**REHABILITATION OF THE SUROOR
ELEMENTARY SCHOOL
UNDER THE ECONOMIC SUPPORT FUND
HUSSEINIYA, IRAQ**

SUSTAINMENT ASSESSMENT

**SIGIR PA-08-135
APRIL 7, 2009**

Figure 2. Architectural layout of the school after renovation (Courtesy of GRC)

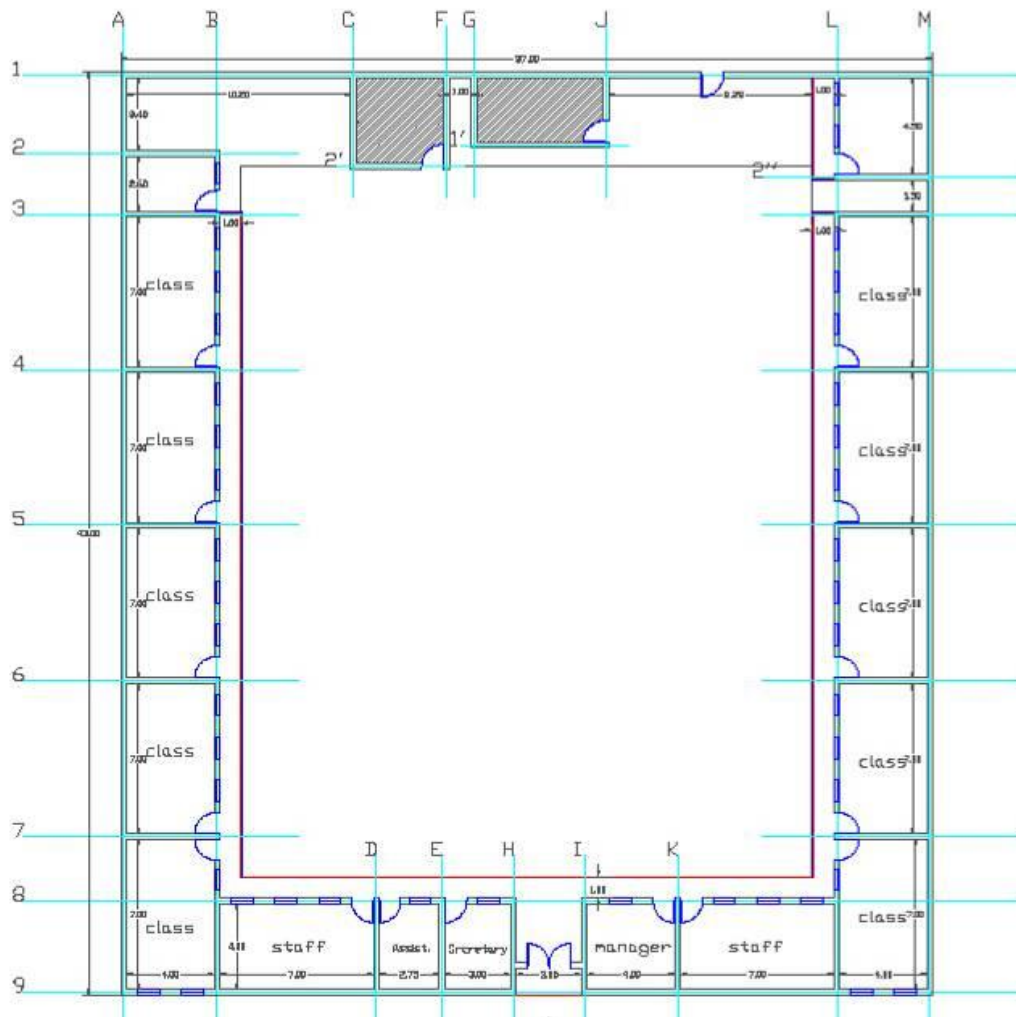
The architectural plans show the layout of 10 classrooms, 2 staff rooms, and administration areas (Figure 2). While the contractor's submittals included good details of the electrical distribution system, our review concluded that the design submittals did not appear adequate for the renovation project because of the omission of details such as elevations, plumbing, and storm drainage.

GRD disagreed and stated it was "appropriate for the contractor not to include storm drainage details in their submittal" since the SOW did not specifically address storm drainage or civil site work. However, this project included the replacement of colored tiles in the courtyard; therefore, civil site work designs were necessary and drainage for the courtyard needed to be addressed by the contractor in the design submittals.

Command Comment. The lack of plumbing details in the design submittals is appropriate since the draft report mentions in the first paragraph on page 3, "The school's administration told GRC that work previously identified by the PRT, such as the school's plumbing, was being done under a separate Government of Iraq (GOI) contract." The list of items addressed in the SOW on page 3 does not mention any requirement for storm drainage or civil site work, so it is also appropriate for the contractor not to include storm drainage details in their submittal.
